UNITED STATES PATENT AND TRADEMARK OFFICE

10/501,821

Office Action Summary	Application No. 10/501,821	Applicant(s) HEATHCOTE ET AL.	
	Examiner THOMAS DIAZ	Art Unit 3656

2. **Claims 1-19 are rejected under 35 U.S.C. 103(a) as being unpatentable over Okubo et al. (US patent 4608877) in view of Meyers et al. (US patent 4892001).**

Figure i- Okubo et al.'s figure.

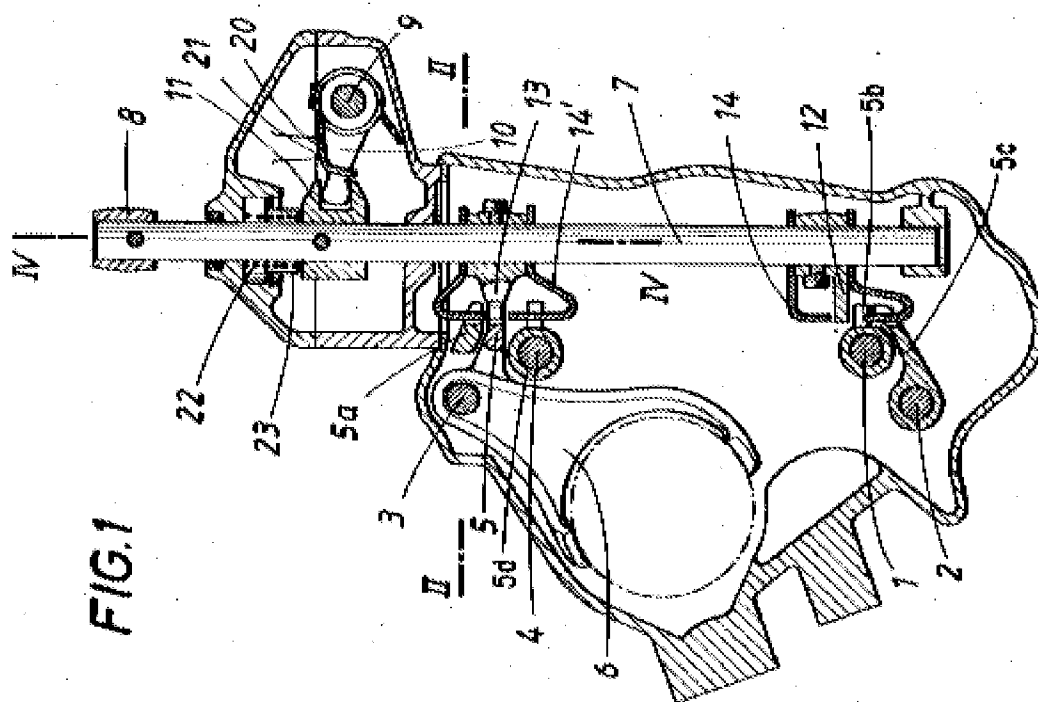
- A shift rail selector element comprising two tongues where the tongues are spaced apart a fixed distance. This corresponds to Okubo et al.'s shift fingers (fig.1, 12 and 13).
- A first and second shift rails which are connected to shift forks and both having interlocking elements. This corresponds to Okubo et al.'s shift rails (fig.1, 1 and 3), connected to shift forks (fig.1, 6) and (fig.2, 6'), and also having connecting members (fig.1, 5b, and 5).

Applicant claims a third shift rail connected to another shift fork and having an interlocking element, which corresponds to the shift rail (fig.1, 4) and shift fork (fig.3, 6a) and connecting member (fig.1, 5d), disclosed by Okubo et al.

Applicant claims the gear shifting mechanism having two groups of shift rails where each group has two shift rails which corresponds to the two groups (fig.1, 1 and 2) and (fig.1, 3 and 4) presented by Okubo et al.

Applicant claims that the distance between the tongues are greater than the distance between two adjacent interlocking member which Okubo et al. discloses as depicted in figure 1. The distance between shift rails 1 and 2 is less than the distance between tongues 12 and 13.

Applicant claims that the distance between the selector tongues is smaller than the distance between two spaced apart interlocking elements which corresponds to the relationship of distances between the tongues and connecting members 5a and 5c disclosed in Okubo et al. figure 1.

Applicant claims that all the interlocking elements have a width which is less than the width of the respective shift rail measured in the same directions. Okubo et al. discloses this through figure 1, where as seen the width of the connecting members is less than the width of rails.

Applicant claims that the width of the interlocking elements is approximately half the width of the respective shift rail measured in the same direction. This is also depicted in figure 1 of Okubo et al. in particular where connecting member 5b is approximately half the width of rail 1.

Applicant claims that the width of the tongues essentially correspond to the width of the interlocking elements which corresponds figure 1 of Okubo et al. where the width of the tongues (fig.1, 12 and 13) essentially correspond to the width of the connecting members 5, 5a-d).

Applicant claims the selector element having a blocking element which blocks the shift rails when the tongues are at least in partial engagement with the shift rails. This corresponds to what is blocking members (fig.1, 14 and 14') which block the shift rails from being moved when a tongue is at least in partial engagement with the shift rails (col. 3, lines 17-20), disclosed by Okubo et al.

Okubo et al. discloses that the blocking element is arranged on a support (fig.1, 7) which is seated displaceably in the first direction and in this direction is connected with the shift rail selector element (fig.1, 12 and 13; These elements are rotatable.), wherein the shift rail selector element is freely movable relative to the support in the second direction.

Okubo et al. discloses that the shift rail selector element is resiliently biased towards its center position by means of at least one spring element (fig.1, 22; biases the selector elements in the first direction.) at least in the first direction, in which its selector tongues are not in engagement with the interlocking elements of the shift rails, or in which its selector tongues are in engagement with the interlocking element of a selected shift rail.

Okubo et al. discloses that the shift rail selector element (fig.1, 12 and 13) is seated, movable in the second direction, on a support (fig.1, 7; can move in the first direction), which in turn is seated, displaceable in the first direction, in a housing (see fig.1, the bar is seated in a housing), wherein the shift rail selector element has a means for a connection with a known selector finger (fig.1, the shift rail selector element is connected to the selector finger 10, through element 11).

Figure iv- Meyers et al. figure.

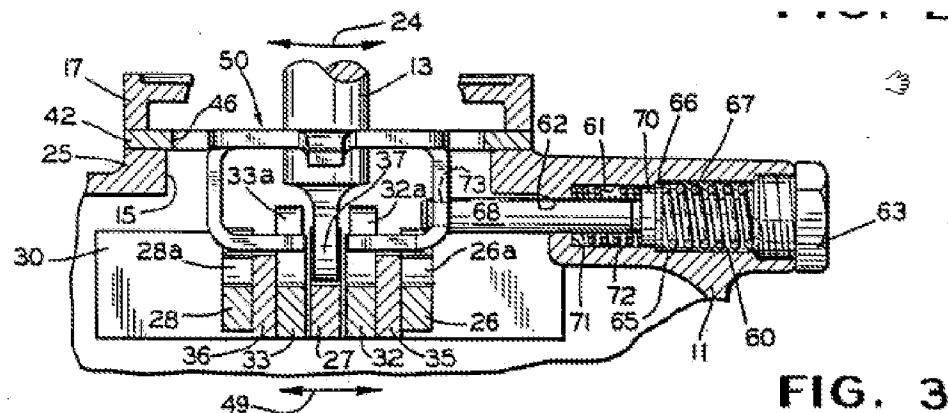
Meyers et al. teaches the use of shift rails (fig.3, 26,28) which include a flat side (see fig.3, flat side of 32 or 33), and a trough-like depression (fig.3, depression formed on element 33 and 32) extending through the flat side thereby defining a reduced wall area (fig.3), and wherein each reduced wall area includes an aperture (fig.3, 33a and 32a) formed therein. Meyers et al. teaches the use of this shifting mechanism for the purpose of providing an improved interlock assembly for preventing more than one of a plurality of shift bars from being selected at a given time (col.1, lines 6-11).

Please note that the shift rails taught by Meyers et al. are composed of three parts, (i.e. rail 28 includes 36 and 33 and 26 includes 35 and 32). The reduced wall area is formed on rails (28 and 26) since the depressions formed on parts (32 and 33) do not extend past the middle parts (35 and 36) of the shift rails.

Meyers et al. teaches a support (fig.3, 50) which has an extension or shaft (fig. 3, 68) which supports a spring (fig.3, 67 and 72) which is supported between the driver plates (fig.3, 71 and 66), and stretched between detents (fig.3, 70) formed on the shaft and where two stationary contact faces (fig.3, 70 and 71), for

Examiner notes, the contact faces 70 and 71 are stationary when the shift lever is in a centered and neutral position or at equilibrium.

It would have been obvious to one of ordinary skill in the art at the time the invention was made to modify the Okubo et al. to include a support (fig.3, 50) which has an extension or shaft (fig. 3, 68) which supports a spring (fig.3, 67 and 72) which is supported between the driver plates (fig.3, 71 and 66), and stretched between detents (fig.3, 70) formed on the shaft and where two stationary contact faces (fig.3, 70 and 71), as taught by Meyers, et al., for the purpose of providing the operator with tactile feedback allowing for the operator to be able to feel what shift bar or rail has been selected (col.2, lines 48-54), and for providing an improved interlock assembly for a vehicle transmission (col.1, lines 6-11).
